Southern California Edison Company

Subject: Docket No. 50-206
10 CFR 50 Appendix G, Fracture Toughness (GL 88-11)
San Onofre Nuclear Generating Station
Unit 1

RESPONSE TO NRC REQUEST FOR ADDITIONAL INFORMATION
REGARDING UNIT 1 RESPONSE TO GENERIC LETTER 88-11Item 1

FIGURE 1. Predicted Decrease In Upper Shelf Energy For SONGS1 Per Regulatory Guide 1.99 Rev. 2

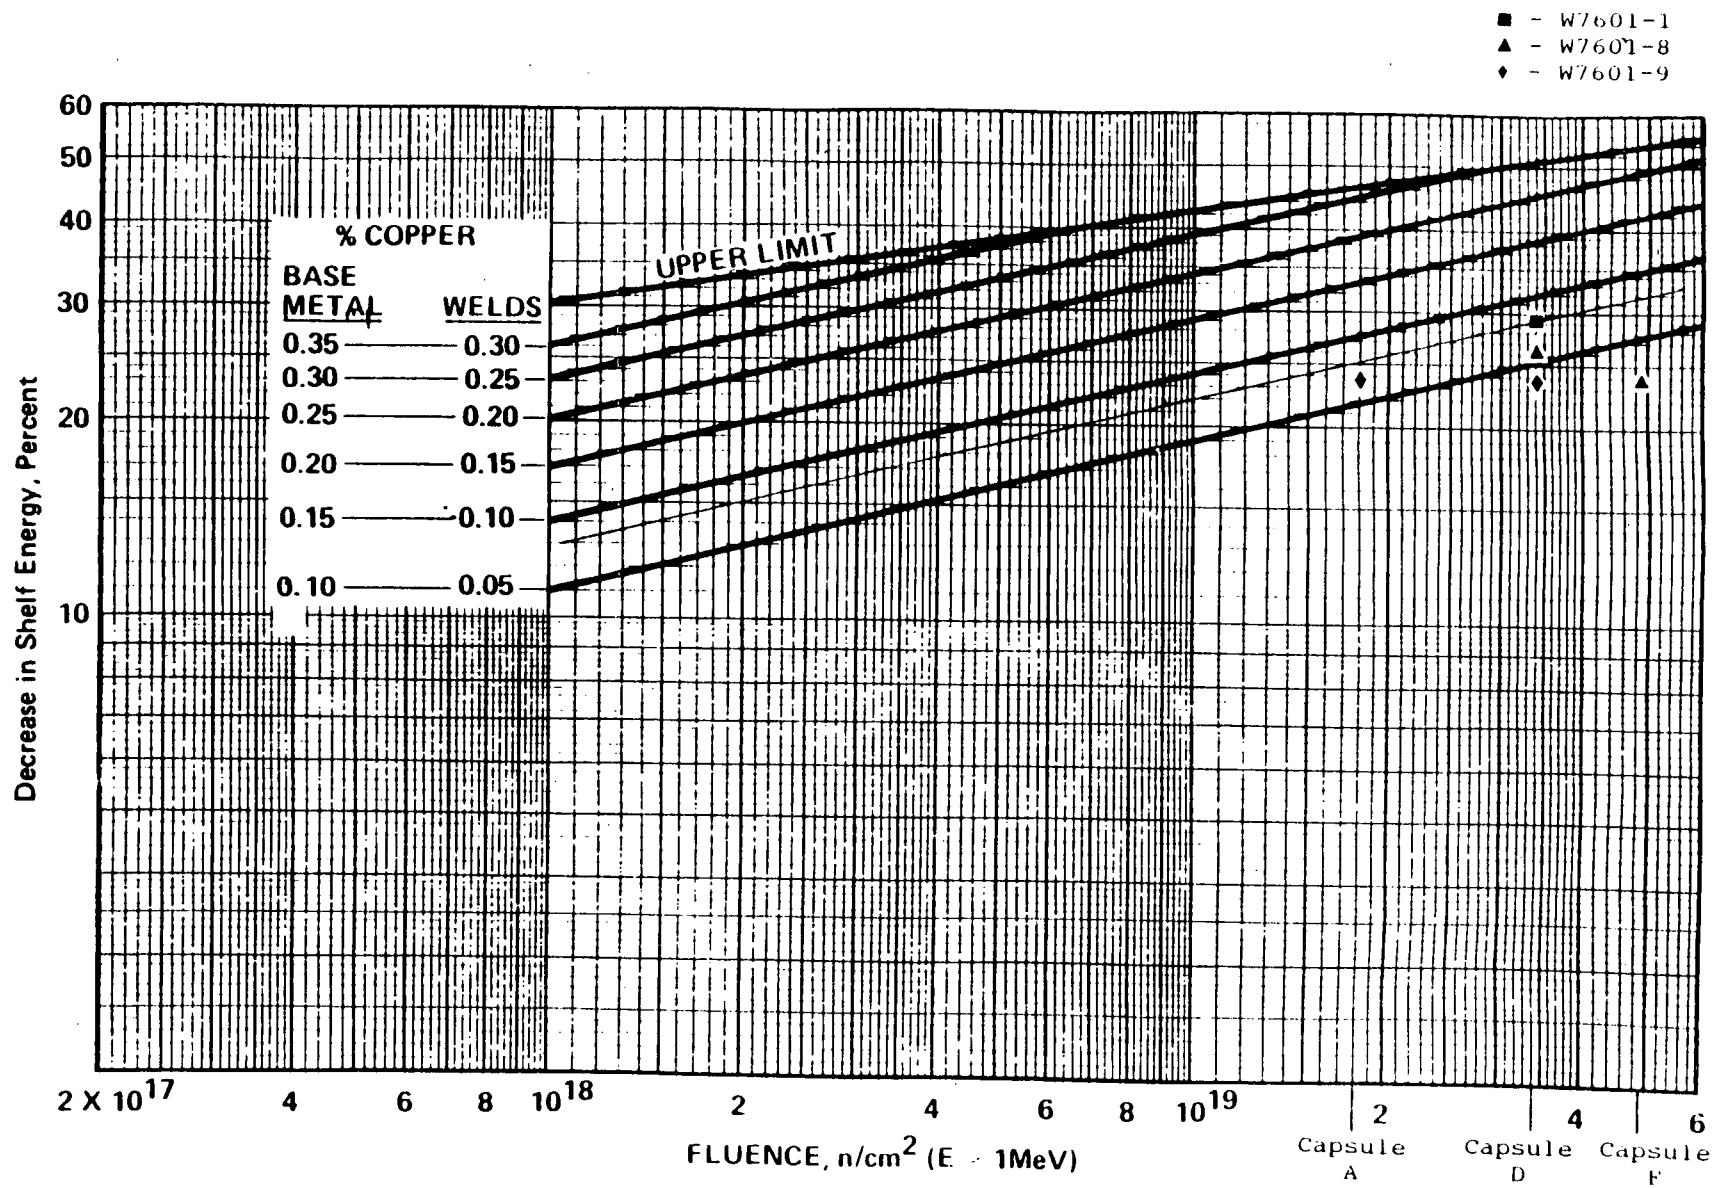
With regard to charpy upper shelf energy, please provide the results of your calculations using:

- a. The methods of R.G. 1.99, Rev. 2
- b. The alternate method that was discussed which credits saturation effects. In this case, also provide supporting details for your conclusions.

At the request of the NRC, the beltline USE was also evaluated using R.G. 1.99, Rev. 2. SCE used Section C.2 which credits surveillance data for determining the USE. Updated fluence data, surveillance data from the SONGS 1 program, and the methodology of Section C.2 were used for determination of USE. SONGS 1 surveillance data is listed in Table 2. Data for all 3 surveillance capsules have been grouped and plotted in Figure 1.

Bounding the data in Figure 1 and using the lowest unirradiated transverse USE (71.5 ft-lbs), plate W7601-9 is limiting and would be predicted to currently have an USE of 53.1 ft-lbs. USE for this plate would be predicted to drop below 50 ft-lbs at 24.7 EFPY (see Table 3) based on R.G. 1.99, Rev. 2, which is beyond the current projected plant EOL.
